CITY OF BAY MINETTE PLANNING COMMISSION

Request: Site Plan Approval for Popeye's Restaurant

Case No. SP-2101
Out of the Box Ventures, LLC Property
Site Plan Approval Request for Popeye's Restaurant
January 14, 2021

North Baldwin Utilities has reviewed the civil plans dated 11/23/20 and offers the following comments:

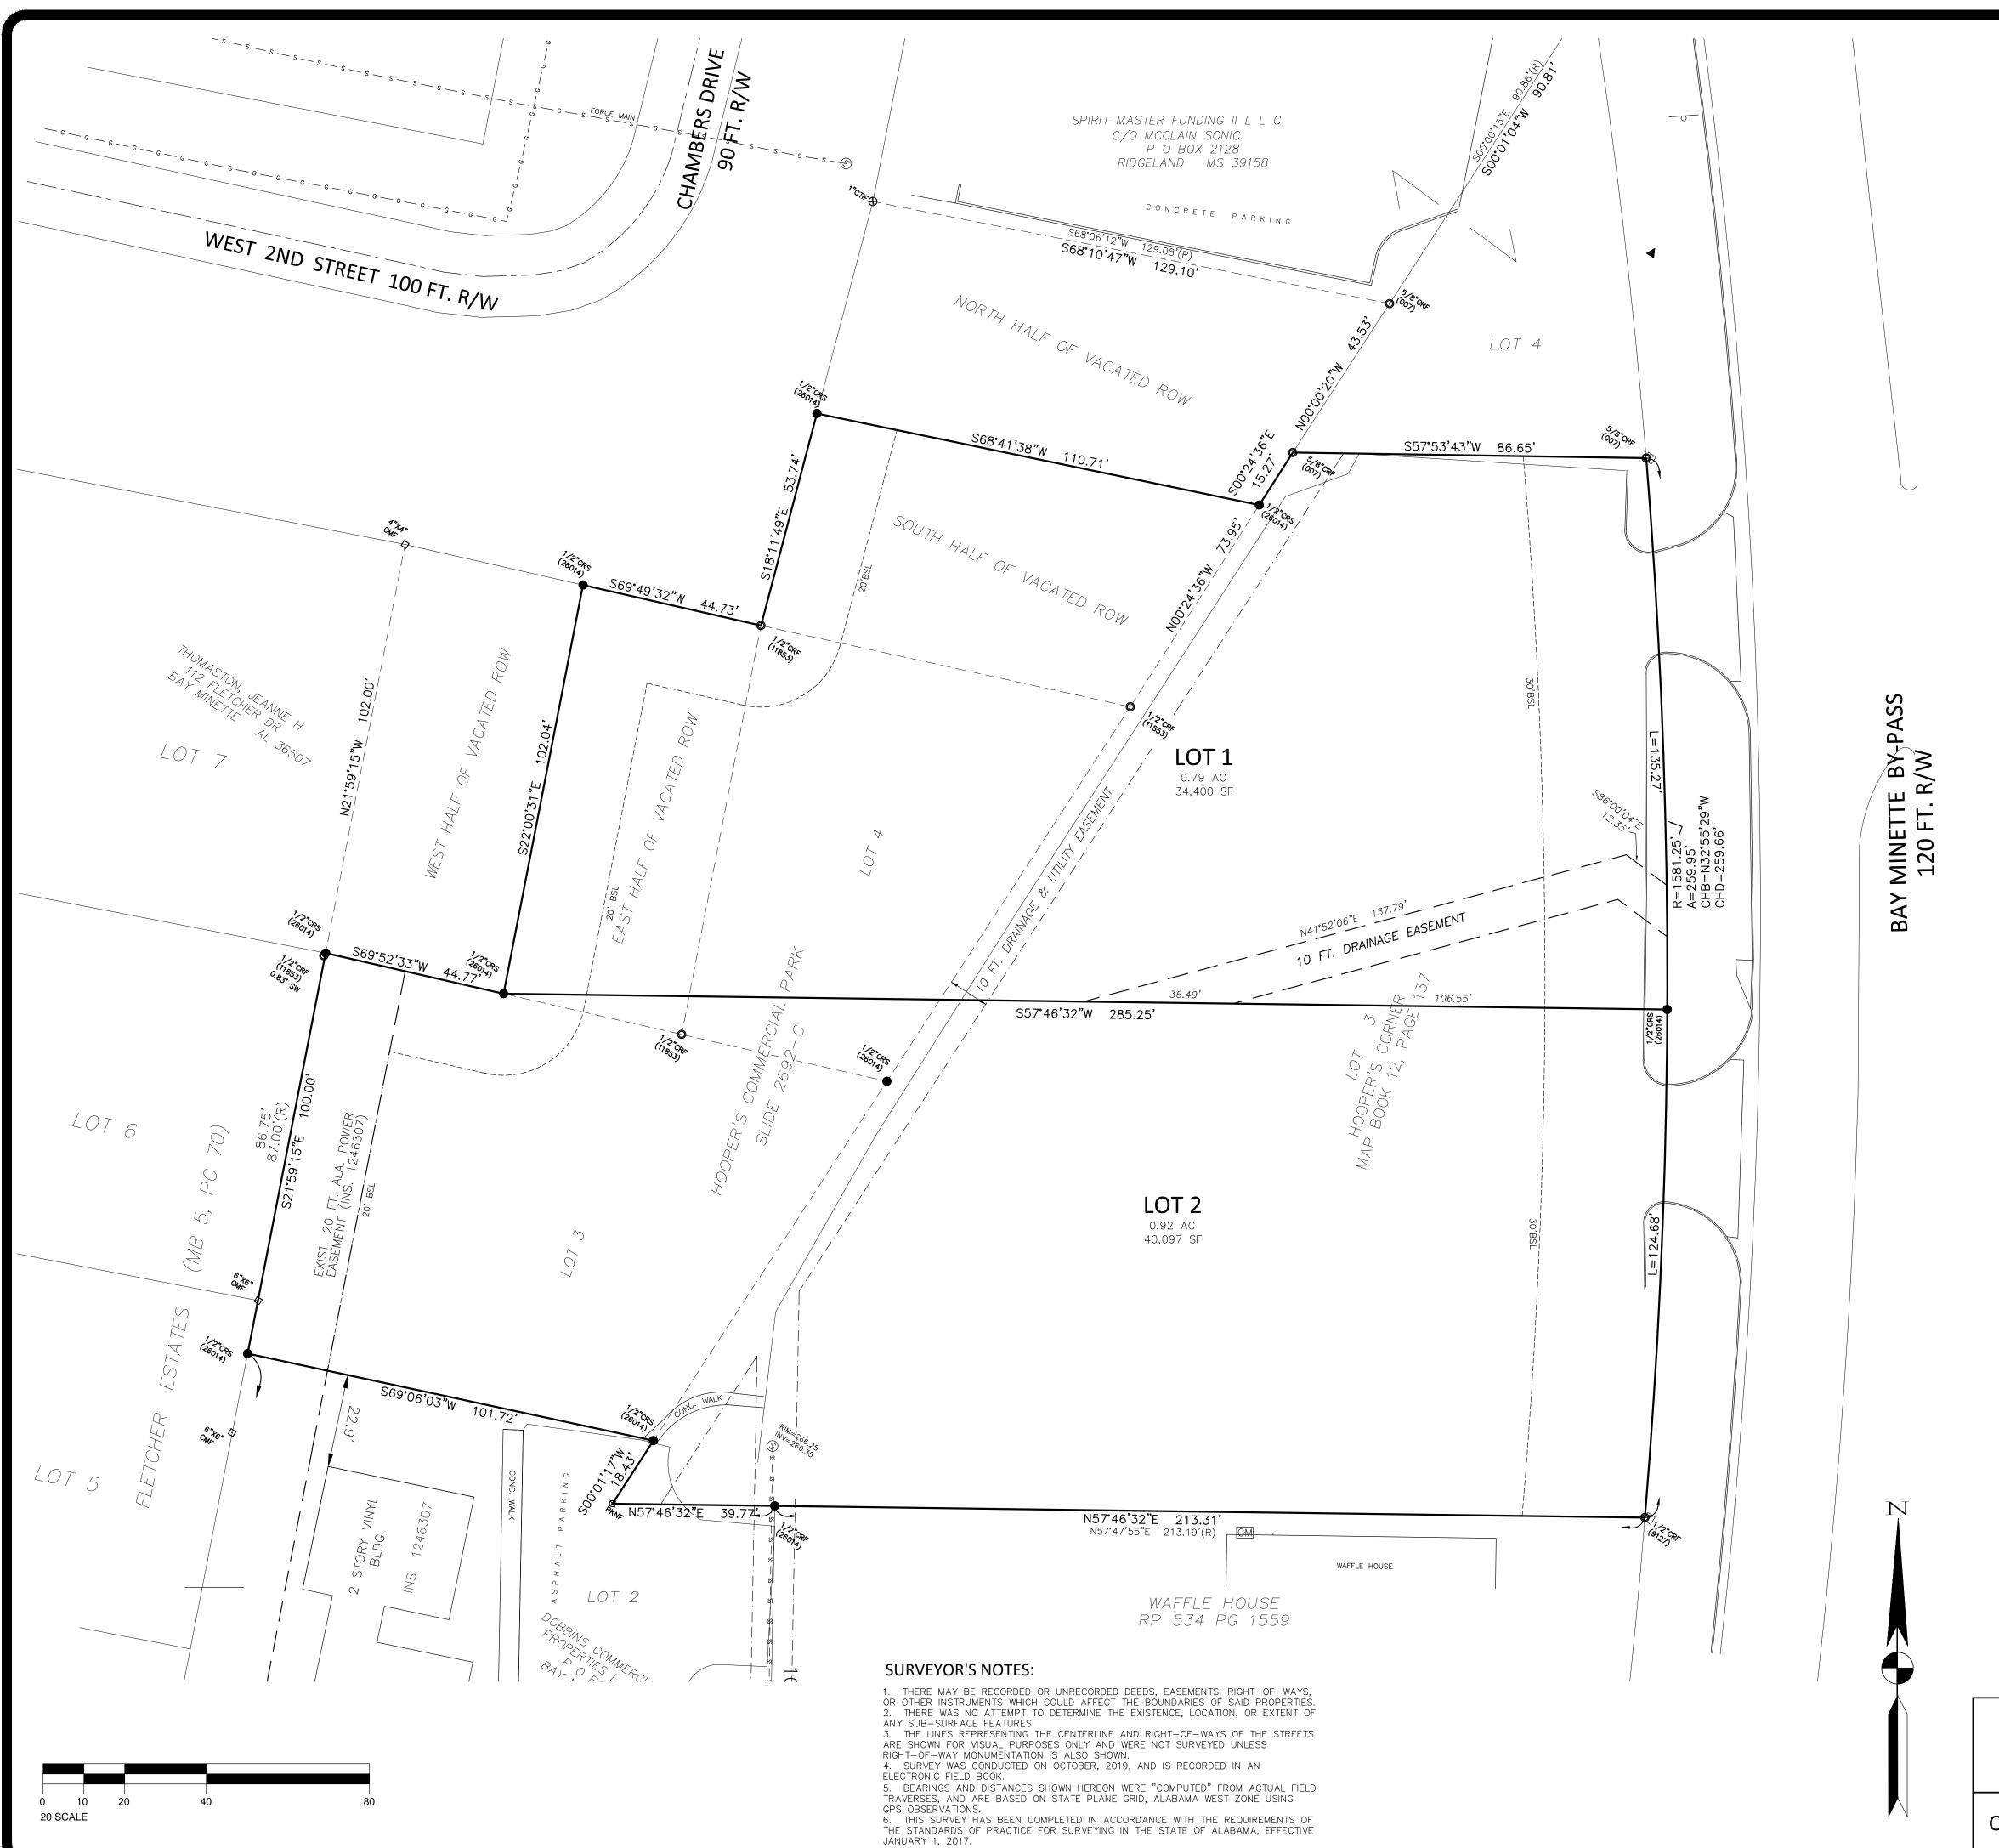
- Where is this power pole on the plan set? Will this be relocated?
- Are there any existing utilities underneath the proposed turn lane? If so, please show.
- Sheet C02
 - Stop line needs to be shown for the right out.
 - The double yellow stripe needs to stop at the STOP line instead of continuing to EOP
 - Add a Right Turn Only sign mounted below the stop sign
- Southern-most access needs to be removed and replaced with curb.

- ALDOT STDs Turn Lane Build up is missing from details please add.
 - o Use following Buildup for Turn Lane:
 - Wearing Surface Layer, 1.5", 165 LBS/SY
 - Upper Binder Layer, 2", 220 LBS/SY
 - Lower Binder Layer, 3", 330 LBS/ SY
- The S-inlet needs to be shown on all sheets that show the curb.
- There are two separate details for the inlet and junction box. The detail with index number 62160 on sheet C23 is not applicable.
- The ALDOT details should be the only details used for the junction box and inlet on ALDOT ROW.
- The other details that are not ALDOT Standards shall not be used on ALDOT ROW.
 - The wing catch basin and manhole details on sheet C14 need to be noted these are only for construction OFF ALDOT ROW.
- The call outs on Sheet CO3 need to be corrected and be referred to as the ALDOT Standard detail for each junction box and inlet.

SITE - LANDSCAPING NOTES

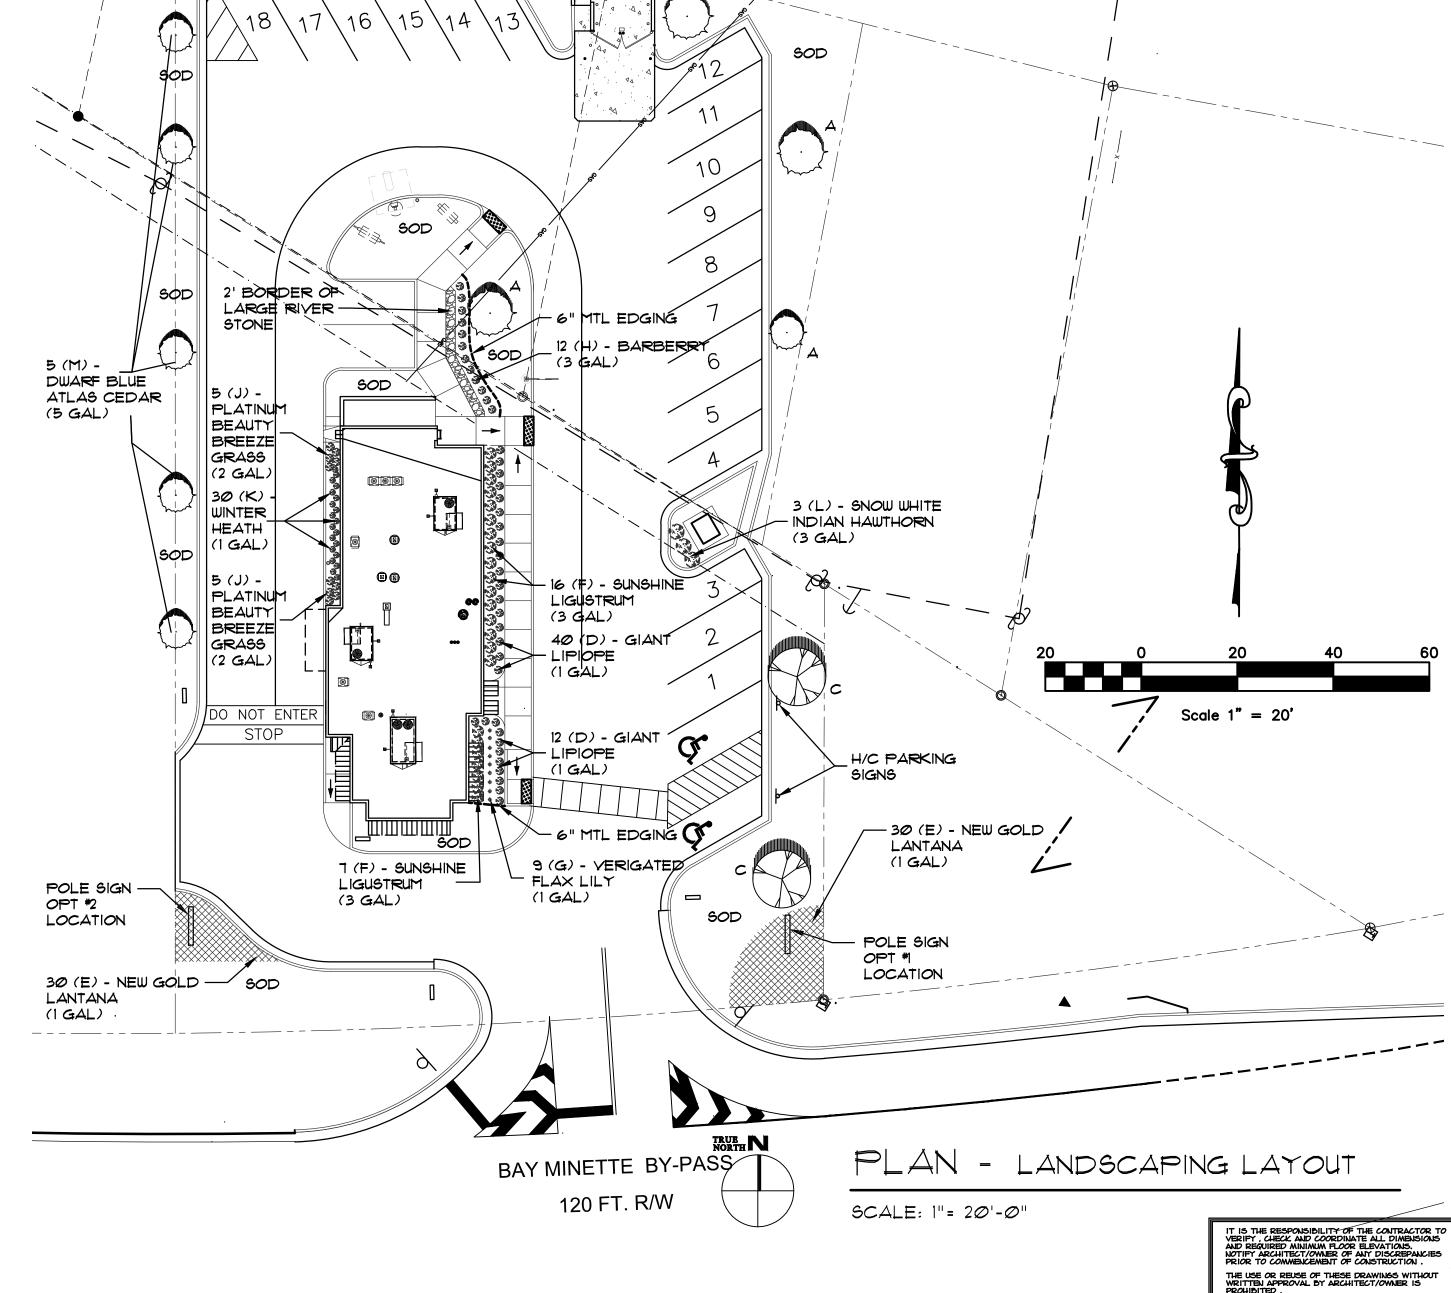
Approximately .27 acres (34.18%) of the site is proposed for grassed/landscaped area, a minimum of 15% of the total lot area is required. The proposed Landscaping Schedule listed below, will need to be modified to meet the regulations of 10.5.2, which states all shrubs shall be installed as a 5 gallon minimum and all trees installed as 15 gallon minimum.
